RE: City of Kirkland / Watershed Company review comments for 9757 (9900) 124<sup>th</sup> Avenue NE.

BUFFER MITIGATION PLAN  
**CEDARBROOK SP**  
 9757 124TH AVENUE NE  
 KIRKLAND, WA 98033  
 TAX PARCEL NO. 123850-0890

**BUFFER PLANTING PLAN**  
**CEDARBROOK SP**  
 9757 124TH AVENUE NE  
 KIRKLAND, WA 98033  
 TAX PARCEL NO. 123850-0890

**Re: 9757 124<sup>th</sup> Ave. NE (former Gerde Property)** The Watershed Company  
Reference Number: 100714.17

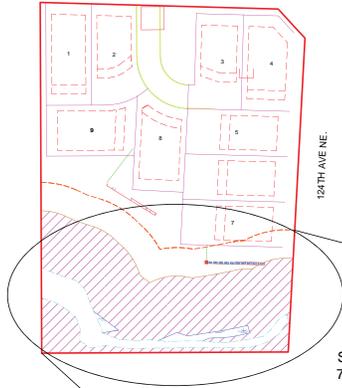
The split rail fence and signs are mentioned only on the legend of sheet W-1. To provide clarity to installation contractors, the fence and signs should be mentioned in the constructions sequence and a detail provided.

SHEET W-2

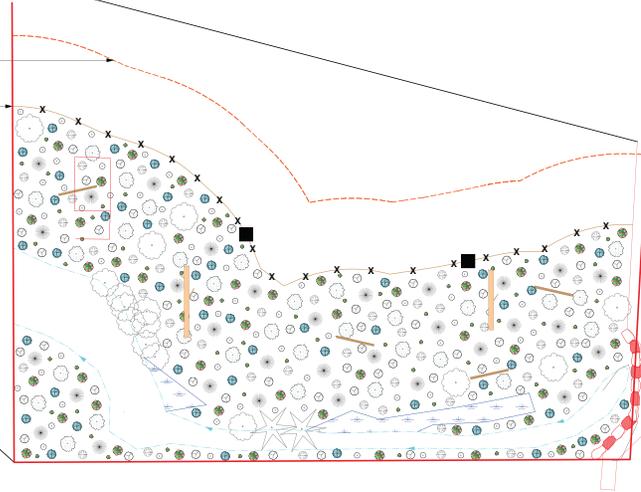
The diversity of tree species should be increased to include one more conifer and at least one more deciduous tree species. Also, since red alder readily volunteers and can form dense monocultures, the proposed quantity should be reduced or a different tree substituted entirely. Good candidates include bigleaf maple and bitter cherry.

The survivability of 4-inch pots on this site is a concern especially due to the dense pasture grasses currently dominating the buffer. Since the proposed quantity of the 4-inch species is quite high, substituting with a smaller number of 1-gallon plants would lower replacement costs in the future.
